Kintore to Tealing 400kV Overhead Line

Summary Report on Consultation - Alignment Selection

January 2025

Figure 14 - Proposed Alignment for Location 4: Careston

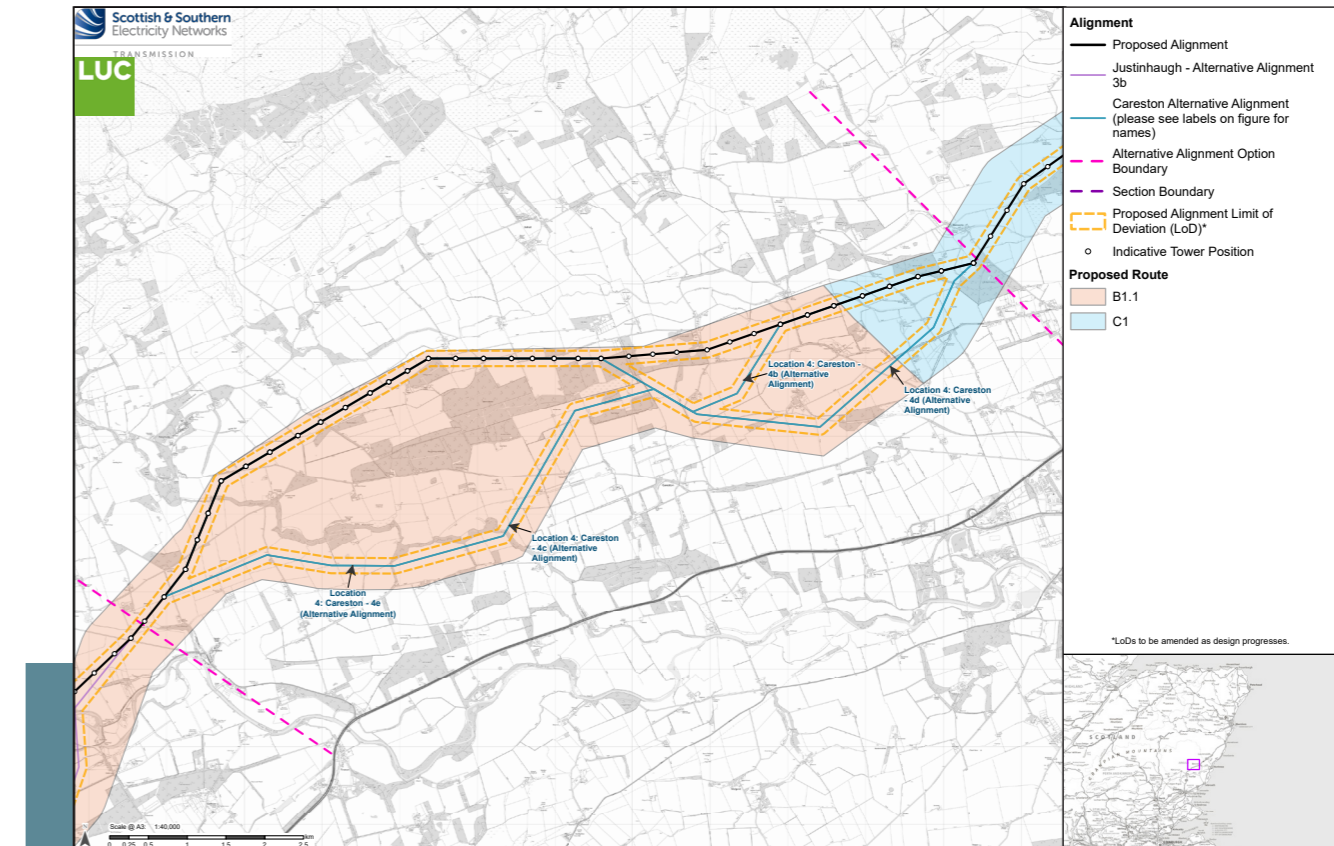
- It was considered that Potential Alignment 4a has less impacts on the environment, residents, properties, and visual amenity compared to the Alternative Alignments.

- Concerns were raised by HES and ACAS regarding impacts on cultural heritage features including Vayne Castle, Vayne Standing Stone and Law of Windsor Cairn. HES confirmed that the Potential Alignment 4a was considered to have least impact.

- Angus Council noted that Potential Alignment 4a was situated within a larger scale landscape and may be more suitable for large structures.
- Some preferred Potential Alignment 4a as it runs in a straighter line and would be better for the environment and the community.

- Potential Alignment 4a was considered to cross poorer quality and flood-prone farmland and therefore was appropriate for an overhead line.
- Potential Alignment 4a and Alternative Alignments 4b and 4d were considered by the Esk DSFB as more preferable for salmon migration.

- It was felt that Alternative Alignment 4b would have less impact on the environment, impacting less woodland and wildlife.
- Alternative Alignment 4b would not cause as much disruption and could traverse poorer agricultural ground, areas that flood and recent conifer planting.
- Some had a preference for Alternative Alignment 4b due to fewer impacts on properties.

- Fewer people would be affected by Alternative Alignment 4d.
- Alternative Alignment 4d would have less impact on valuable woodland areas and wildlife, and would be better screened by trees.
- It was felt that Alternative Alignment 4d poses the lowest risk to the mains gas pipeline in the area.
- Alternative Alignment 4d would not cause as much disruption as it runs through agricultural ground and recent conifer planting.
- Alternative Alignment 4d would help protect the River Cruick and its valley.

- Proximity to property has been reconfirmed and the Potential Alignment 4a is constrained by a slightly greater number of properties than the other alternative alignments. However, it provides the opportunity to maintain a greater distance between the overhead line and residential properties, particularly around the groups of properties in the area of Careston. The overhead line will be developed to maintain a target separation distance of at least 170m or more from residential properties and to maintain a minimum distance of 100m where possible, taking account of other land uses.

- There is a clear difference in landscape and visual constraints with Alternative Alignments 4c and 4e least preferred due largely to their alignment over a prominent and elevated ridge feature. Alternative Alignment 4b is considered to be more visually constrained than Alternative Alignment 4d and the Potential Alignment 4a due to its proximity and wrapping around receptors at Montboy.

- All of the alternative alignments would require some loss of woodlands including areas associated with riparian planting at watercourse crossings and the woodlands at Duns Wood and Lochty Wood. The Potential Alignment 4a would intersect part of Lochty Wood and is more constrained in this location than the comparable Alternative Alignments 4b and 4d however it is considered that groundwater dependent habitats associated with the woodland area could be avoided or mitigated. Alternative Alignment 4d also intersects part of Barrelwell Bog Local Nature Conservation Site (LNCS) which can be avoided with the Potential Alignment 4a.

Having reviewed consultation feedback for this alignment location, including statutory consultee views, and following further survey and design development, on balance it is considered that Potential Alignment 4a remains least constrained overall in relation to the environmental and technical criteria appraised.

In this location we will take **Potential Alignment 4a** forward for the Environmental Impact Assessment and detailed design as our Proposed Alignment, as shown in **Figure 14: Proposed Alignment for Location 4: Careston**.

Figure 15 - Proposed Alignment: Section C

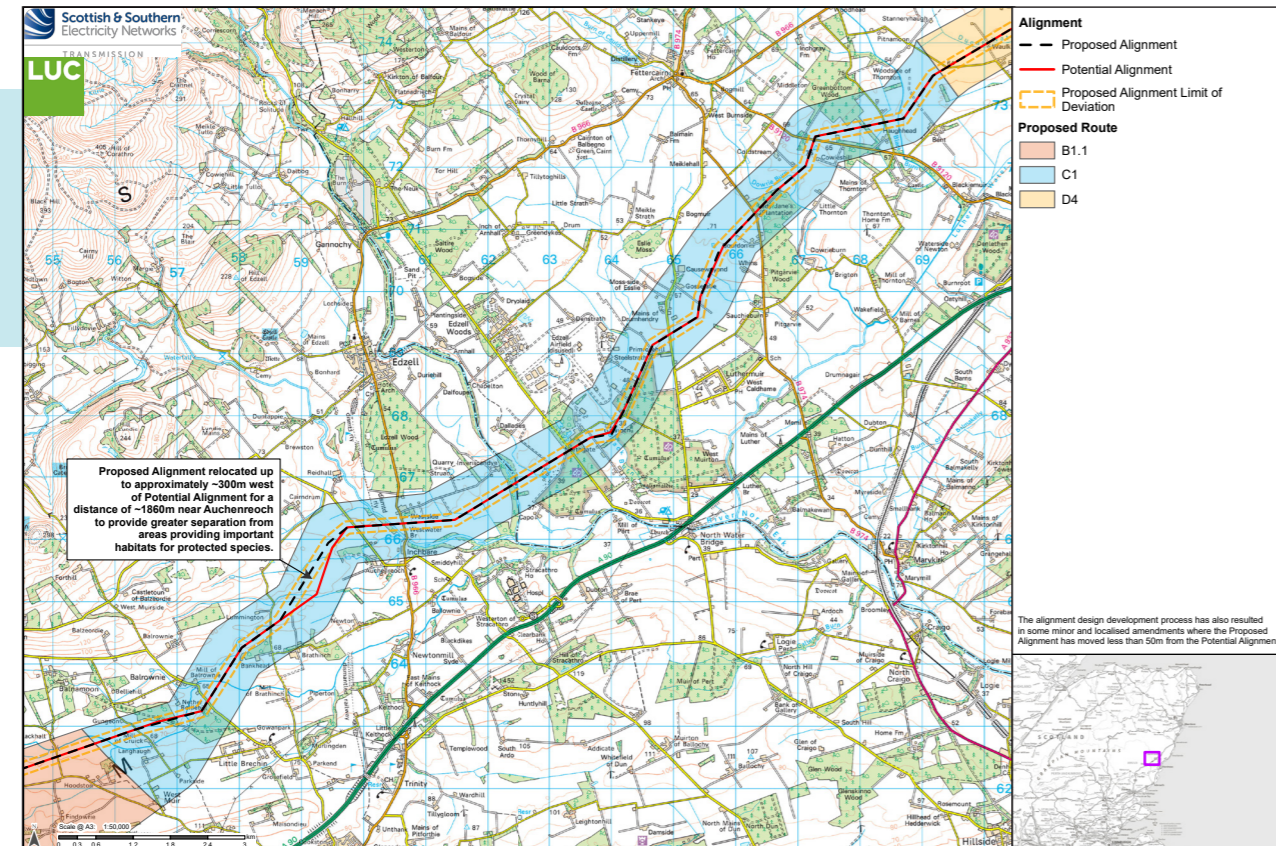
- Community benefits: Suggestions included support for new cycle paths and tree planting to soften the visual impact of the proposed overhead line specifically around Fettercairn.

Having reviewed the consultation feedback for Section C a small change has been made to the Potential Alignment in one location as described below. No other significant changes to the Potential Alignment are proposed.

At Auchenreoch the alignment has been refined to provide greater separation of the overhead line from an area providing habitat for protected species.

In Section C we will take the Potential Alignment forward for the Environmental Impact Assessment and detailed design as our Proposed Alignment, as shown in **Figure 15: Proposed Alignment - Section C.**

Figure 20 - Proposed Alignment for Location 7: Schoolhill

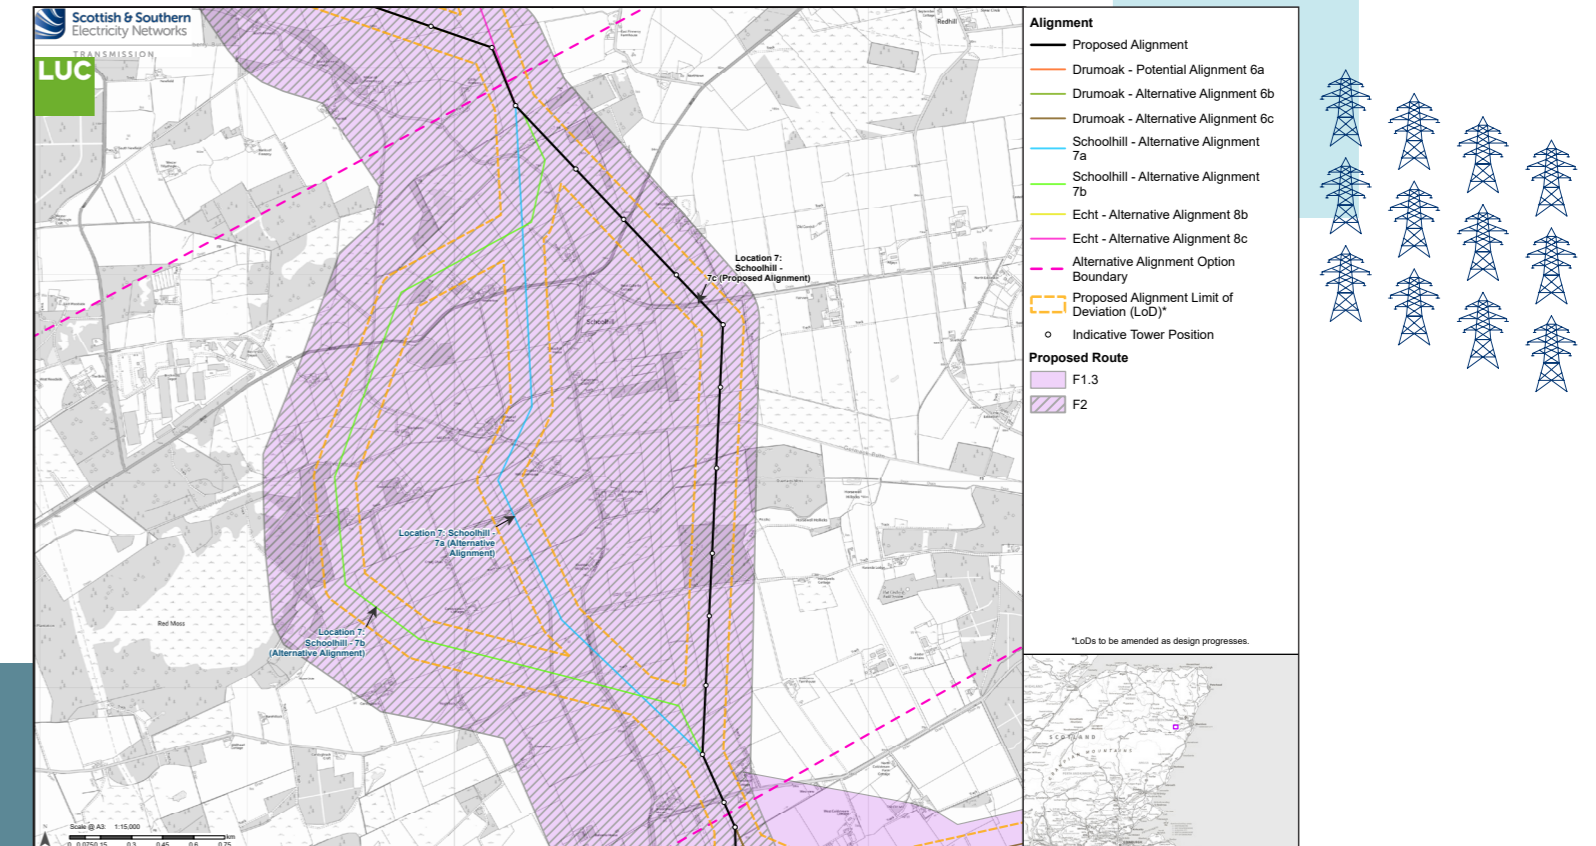
- Alternative Alignment 7c would reduce visual and noise impacts and it is the straighter alignment.
- Alternative Alignment 7c was considered to be furthest away from houses.
- There was a preference for Alternative Alignment 7c in relation to flooding, land use and opportunity for compensatory tree planting.
- Alternative Alignment 7c was preferred to safeguard the local bird populations notably geese.
- Some respondents felt there were fewer health risks associated with Alternative Alignment 7c due to the multiple power lines in Alternative Alignment 7b.
- Concerns were raised regarding the potential to impact cultural heritage assets including Tillyorn Moated Homestead, stating a preference for Potential Alignment 7a or Alternative Alignment 7c to reduce potential setting impact.

Drawing on further site survey findings for these alternatives and post-consultation design development, the environmental and technical issues previously associated with some of the towers for Alternative Alignment 7c have been reduced as we have been able to move some of the tower locations.

In this location we will take **Alternative Alignment 7c** forward for the Environmental Impact Assessment and detailed design as our Proposed Alignment, as shown in **Figure 20: Proposed Alignment for Location 7: Schoolhill**.

Figure 21 - Proposed Alignment for Location 8: Echt

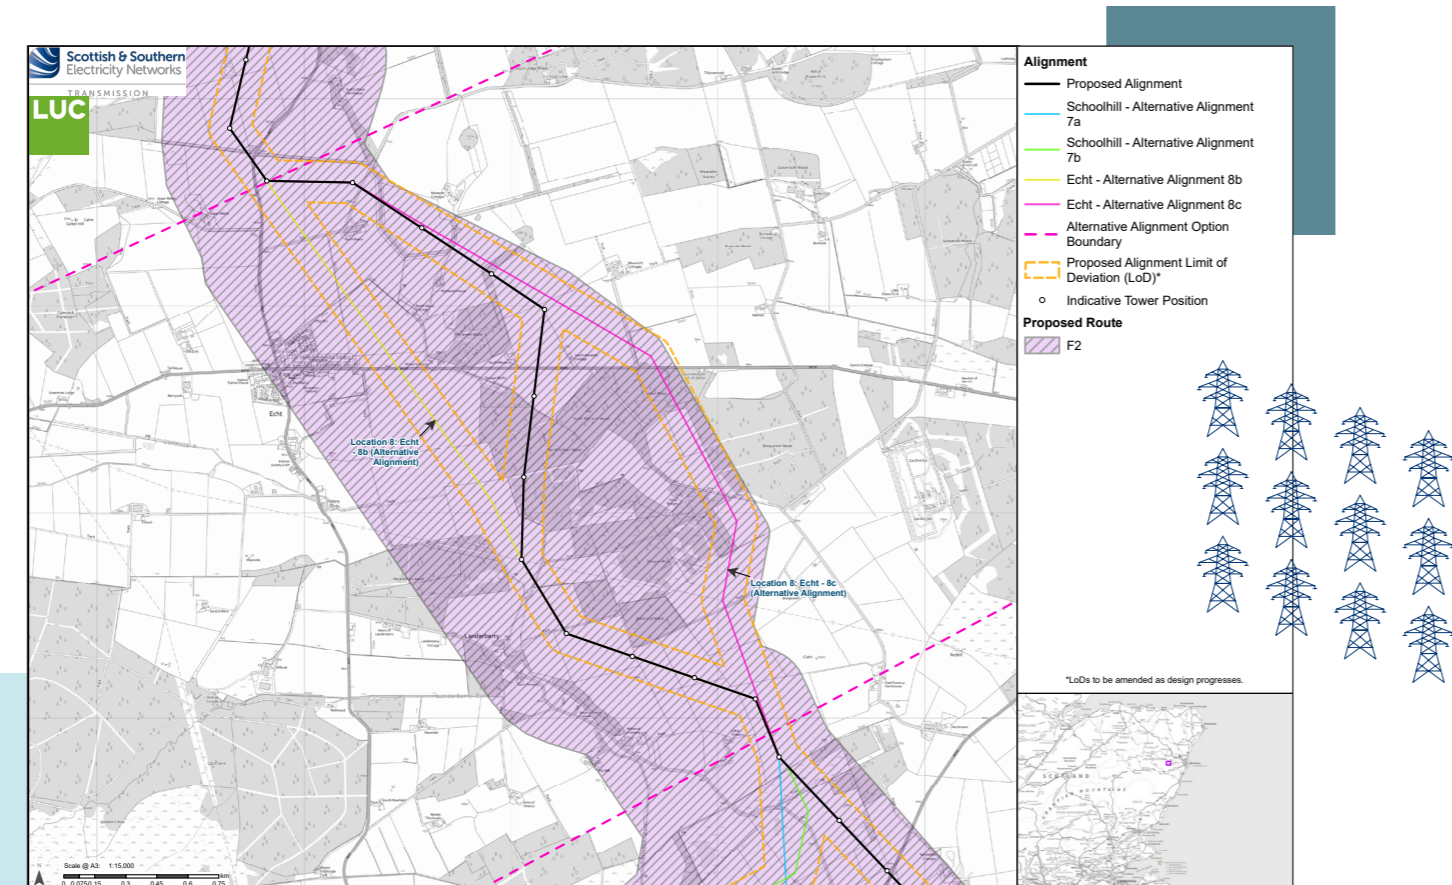
- Alternative Alignment 8b would be unacceptable to some Echt residents as it passes too close to Echt village, the primary school and playing fields, and the 170m separation distance could not be achieved, core paths and planning application site boundaries are also being crossed. There was a preference expressed for either Potential Alignment 8a or Alternative Alignment 8c.
- Potential Alignment 8a would ensure the route does not encroach on the Dunecht House GDL.
- It was considered by some that Potential Alignment 8a and Alternative Alignment 8c would benefit from greater visual screening from the existing trees which would mitigate the impact to the village of Echt.
- Concerns were raised by ACAS and HES regarding the potential to impact cultural heritage features including East Finnelly Cairn, with a preference for Potential Alignment 8a or 8b.

- Concerns were raised about Alternative Alignment 8b near Echt, and a preference for Alternative Alignment 8c as it would minimise visual impacts and avoid areas with planning permission.
- Some respondents suggested Alternative Alignment 8c was the least disruptive alternative.
- Feedback indicated that Alternative Alignment 8b would be unacceptable to some Echt residents, with a preference for Potential Alignment 8a or Alternative Alignment 8c.
- It was felt that Alternative Alignment 8c would avoid the fields that support large bird populations.
- Alternative Alignment 8c would keep the overhead line as far from the school, village and fields used by the community as possible.
- Alternative Alignment 8c was considered by some as the least impactful to the community and recreational space.

In this location we will take **Potential Alignment 8a** forward for the Environmental Impact Assessment and detailed design as our Proposed Alignment, as shown in **Figure 21: Proposed Alignment for Location 8: Echt**.
